ADDENDUM NO. 4  
HWEA CONTRACT # 133-2019-01  
HAMMOND-WOOD WASTEWATER TREATMENT PLANT EXPANSION  
HOPKINSVILLE WATER ENVIRONMENT AUTHORITY  
HOPKINSVILLE, KENTUCKY  
WAUFORD PROJECT NO. 1983

Date of Addendum: Friday, January 17, 2020

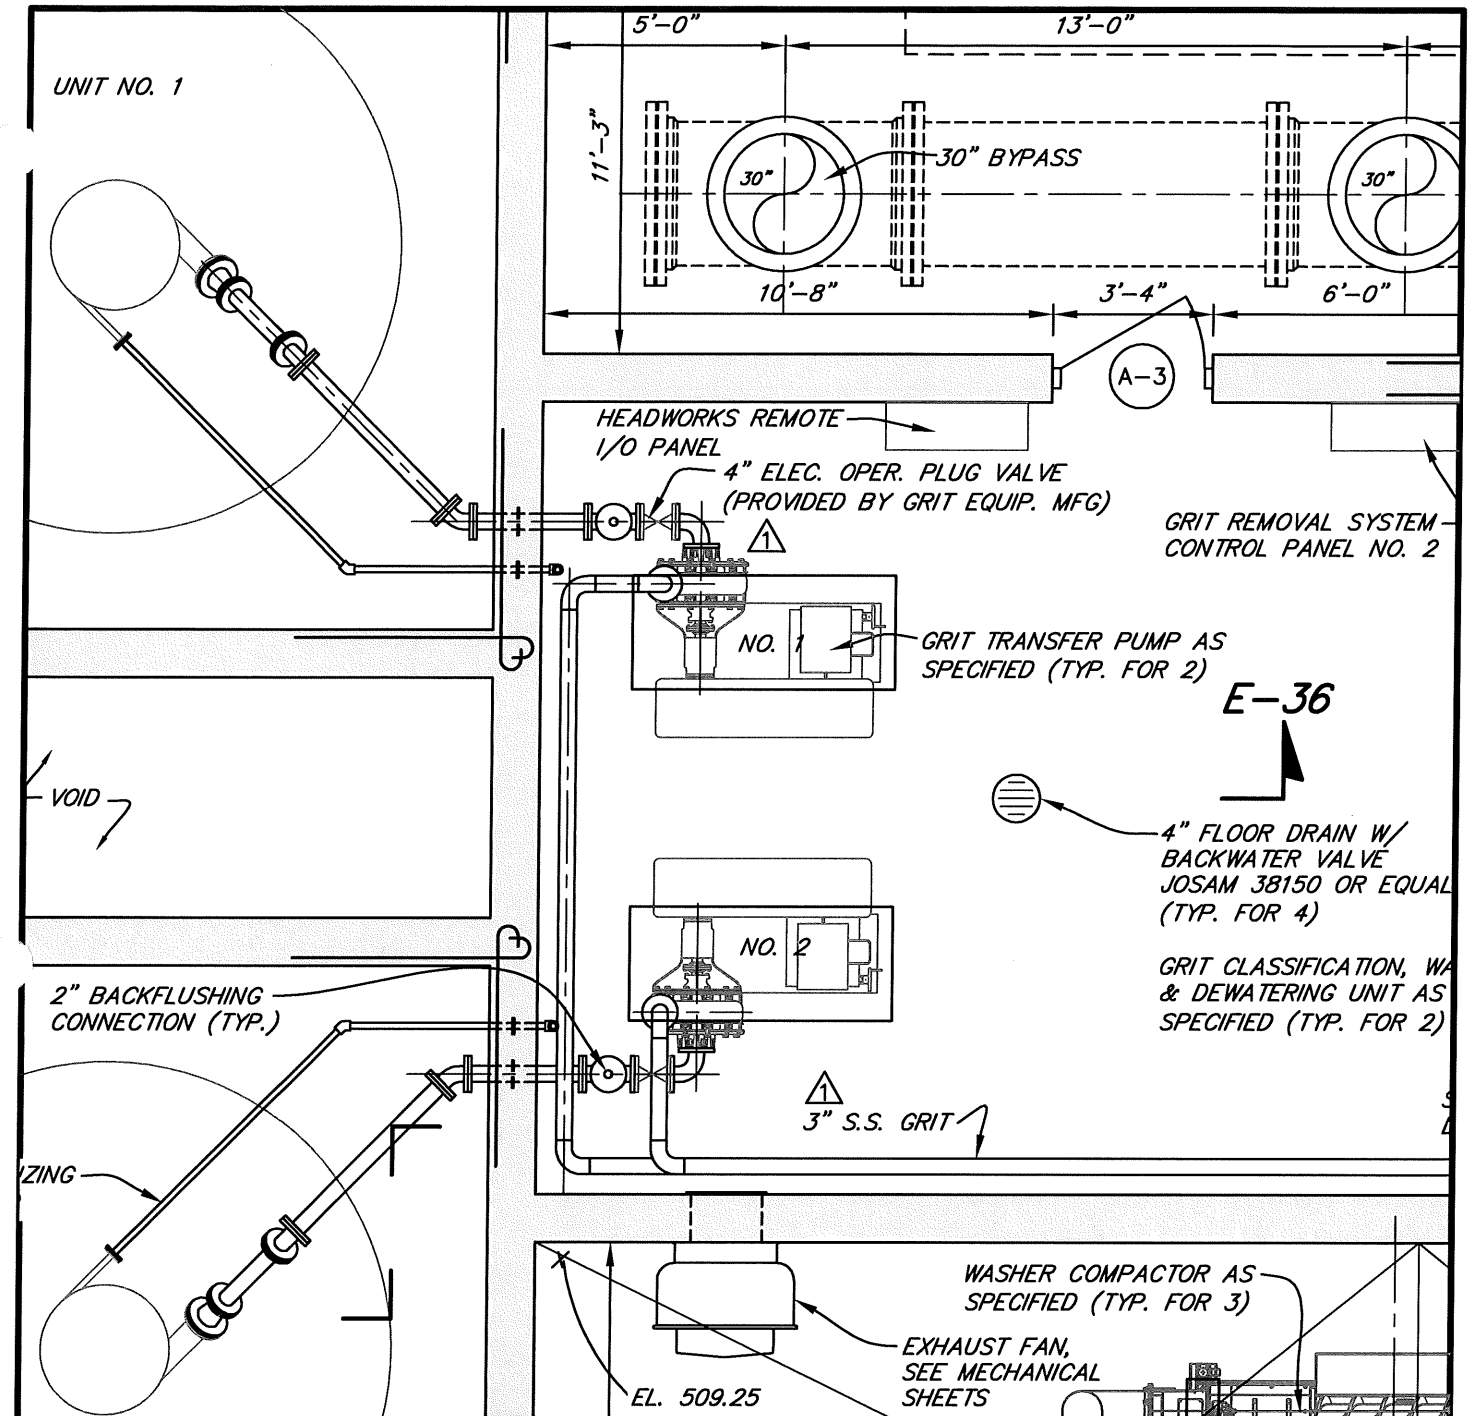
24. Plans, Sheets 34, 35, 36, 81 and 84:

Modify these sheets as shown on the attached 8 ½” X 11” sheets.

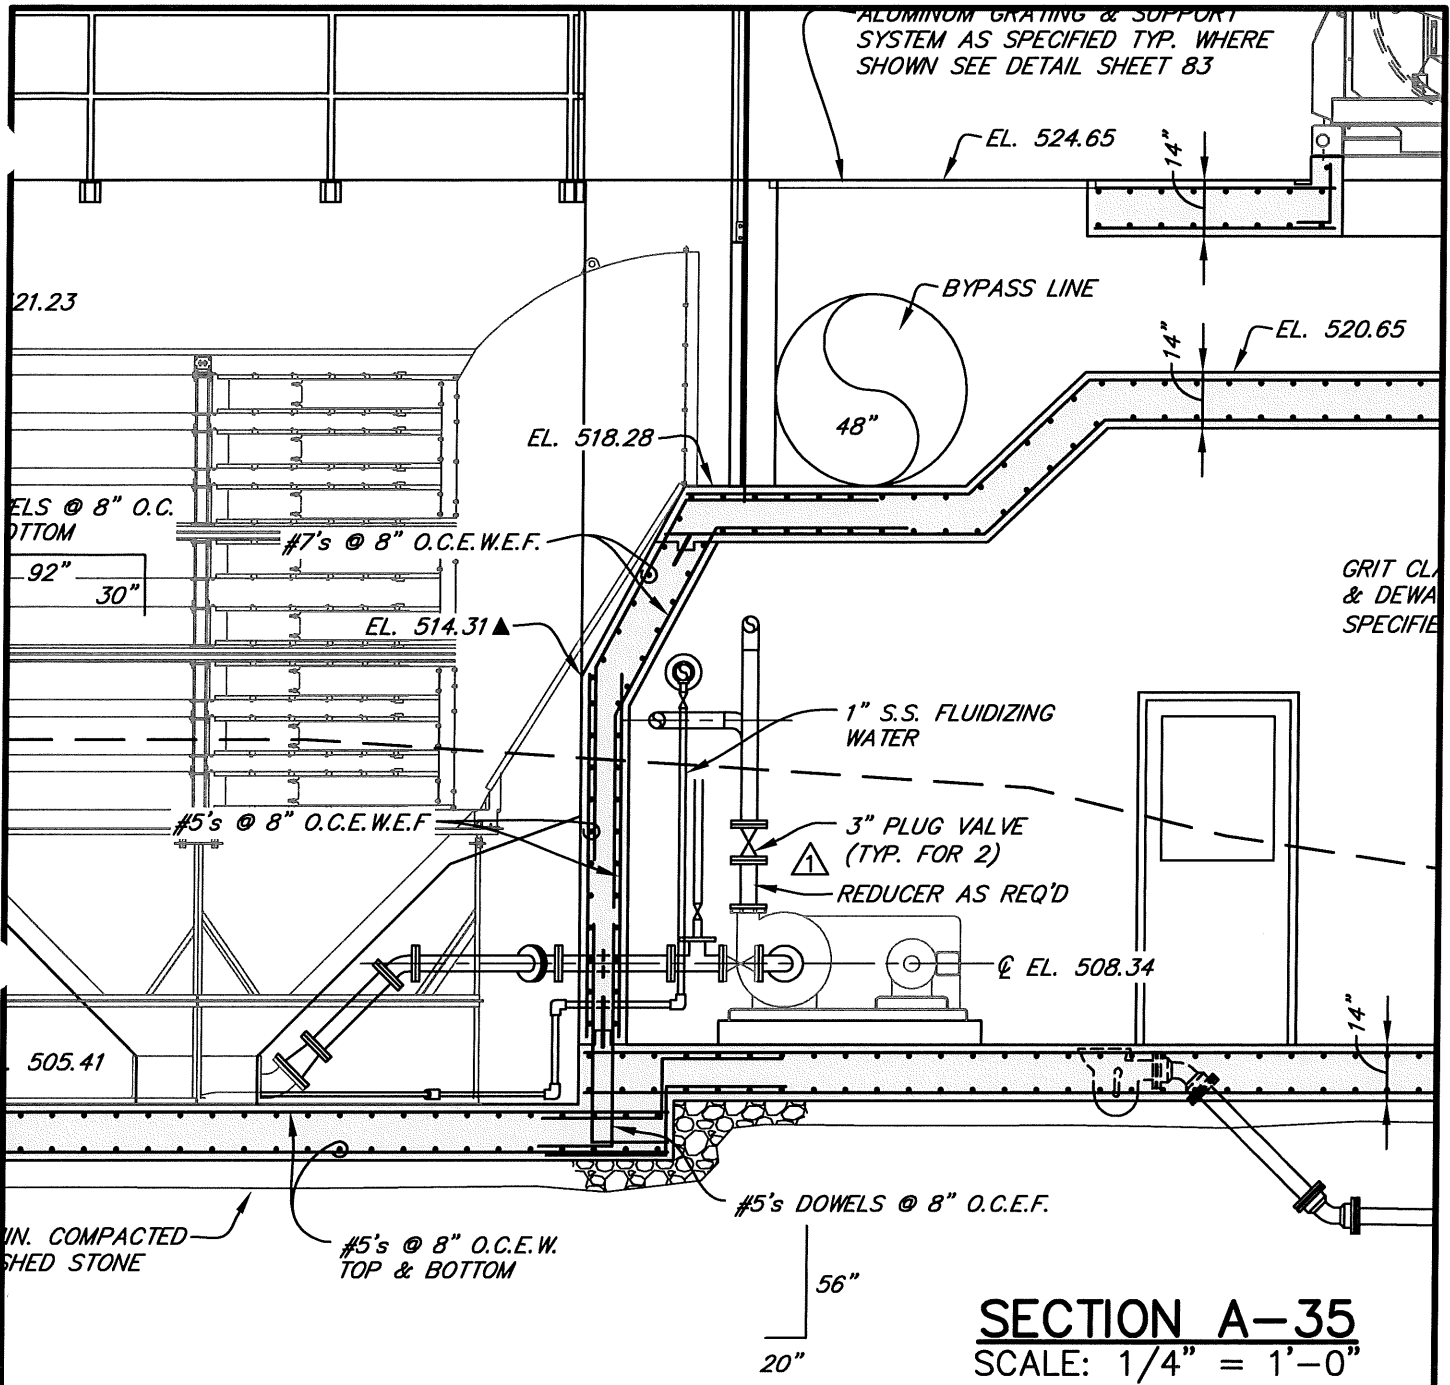
23. Plans, Sheet 35 Construction Notes:

Modify Special Note on Sheet 35 of the Plans as follows:

“NOTE:  
ALL **DRAIN** PIPING UNDER STRUCTURE SHALL BE SPECIALLY LINED & ENCASED IN MIN. 6” CLASS “C” CONCRETE. ALL DIP GRIT SYSTEM PIPING SHALL BE SPECIALLY LINED.”
